S106 Part 1 'Application to connect to a public sewer' Approval Notice

United Utilities Reference Number:	**09150666**
Applicant details	
Applicant name	Chloe Ferry
Applicant address *(including postcode)*	Icosa Water Ltd/Last Mile Fenick House, Lister Way, Hamilton International Technology Park, Glasgow, G72 0FT
Applicant email	wastewater@lastmile-uk.com
Site details: The site / property which is proposed for connection to the public sewer	
Site address *(including postcode)*	Hinchley Road, Manchester, M9 7GA

Drainage drawing below

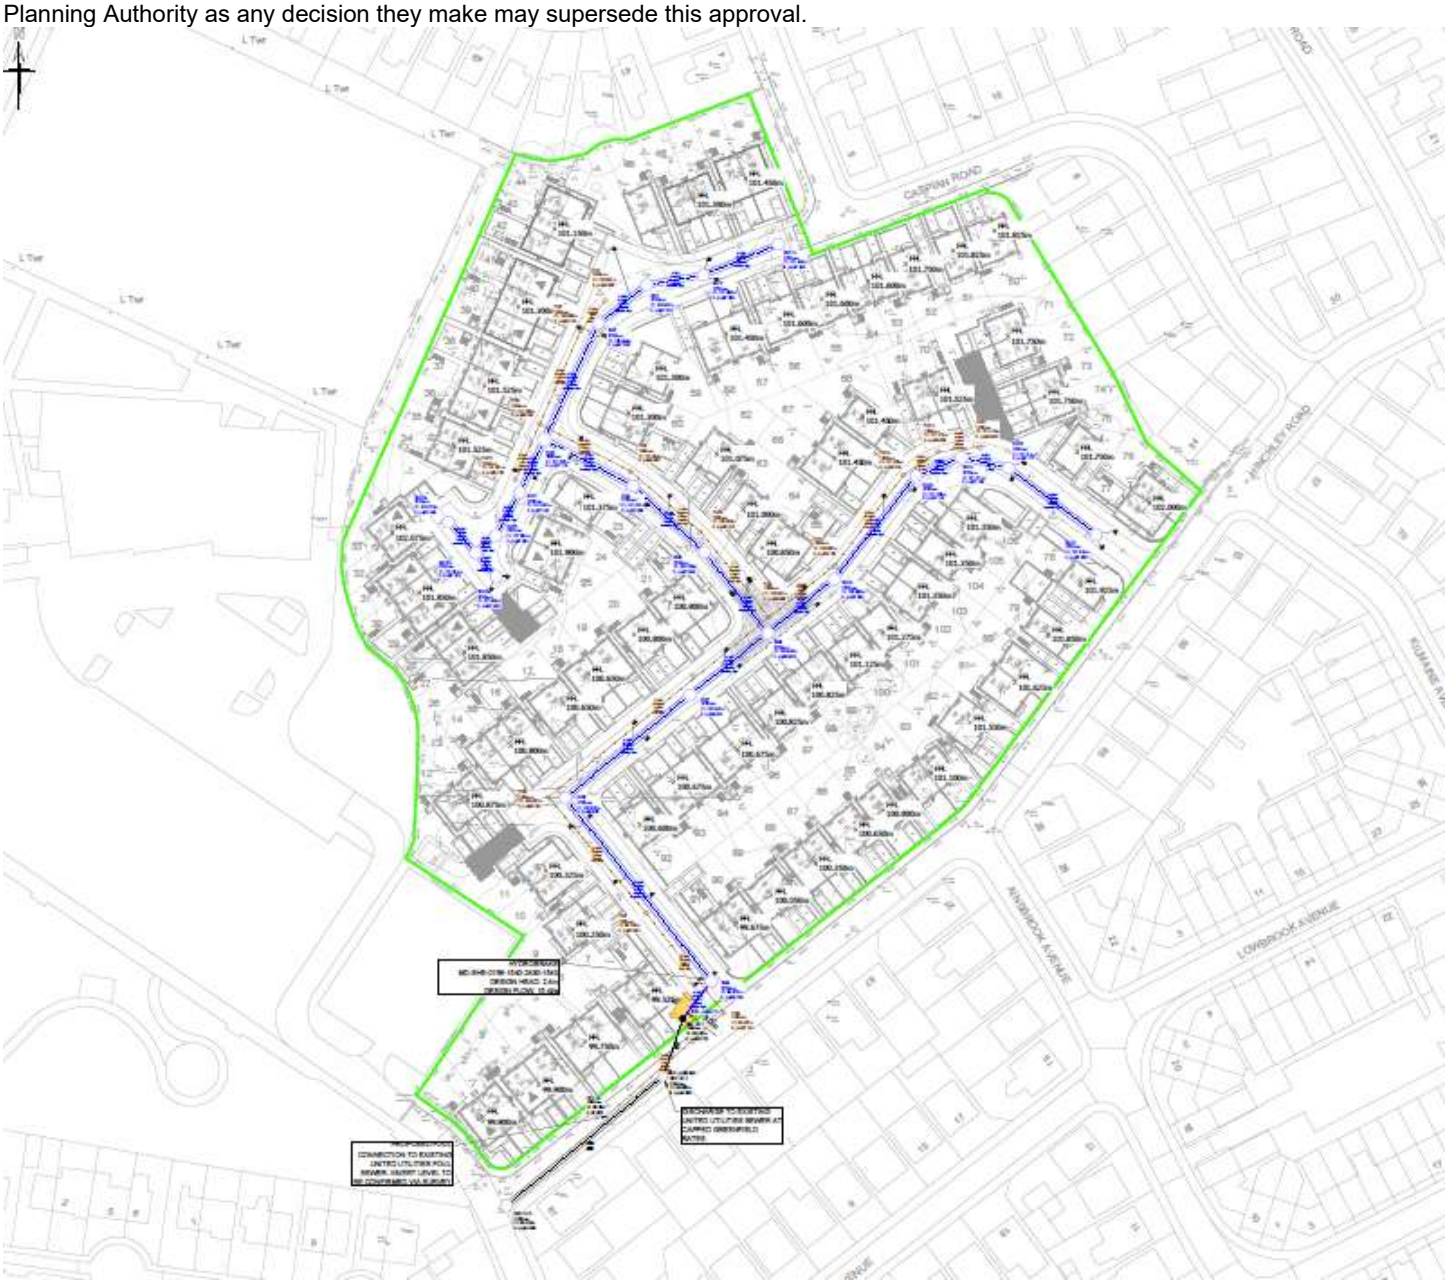
Approval granted for a 100/150mm foul connection to the existing 150mm foul sewer in Hinchley Road via an existing UUMH Manhole number not indicated on the drainage plan but corresponds with our sewer records UUMH7001

Approval granted for a 150mm surface water connection to the existing 1200mm surface water sewer in Hinchley Road via an existing UUMH – Manhole number not indicated on the drainage plan but corresponds with our sewer UUMH8004
Flow control restricted to 15.4l/s – Drainage drawing below
